SUPPLEMENTAL REPORT

Project: Nick DelleDonne, President
Dupont East Civic Action Association, (DECAA)
Masonic Temple Project Zoning Appeal
1733 16th St. NW, Washington DC

We respectfully submit the following additional conclusion with regard to the modified rear yard configuration being proposed by the developer for the 1733 16th St. NW, Washington DC, Masonic Temple Site.

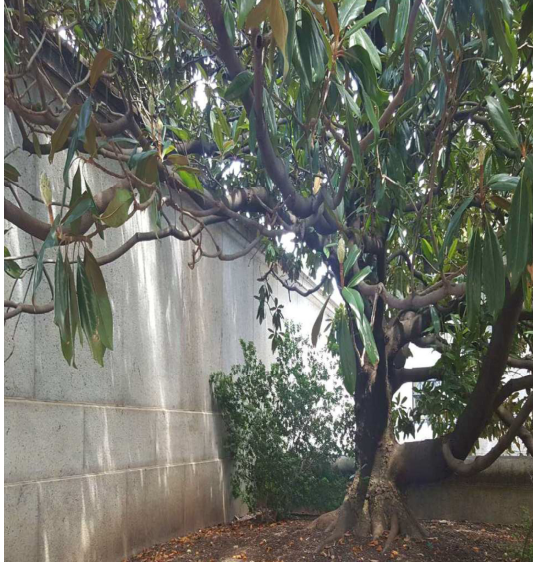
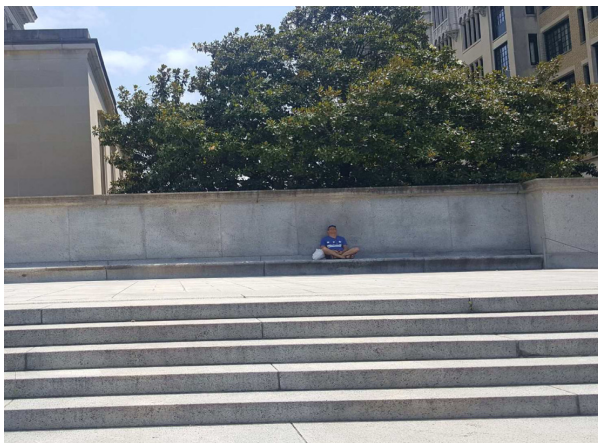
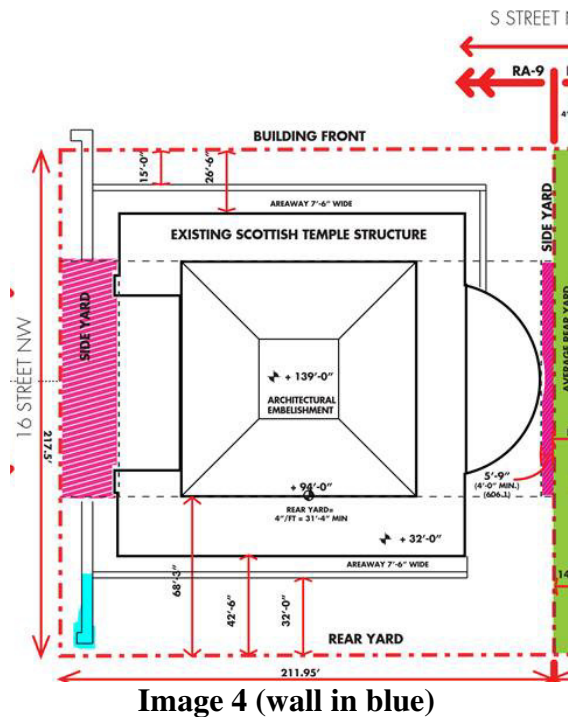
Due to the location of the existing stone wall and column south of the Temple in the proposed rear yard, the proposed reorientation of the rear yard results in a clear violation of 11-B DCMR § 100.2 AND 11-B DCMR § 324.1

Clearly the existing stone wall and column south of the Temple occupy the rear yard, they exceed 4'-0" in height, they do not retain soil or resist a lateral load, they are not necessary to support a stair, nor do they constitute a fence.

The modification of the site configuration to relocate the rear yard to the South clearly violates the provisions for the rear yard requirement.
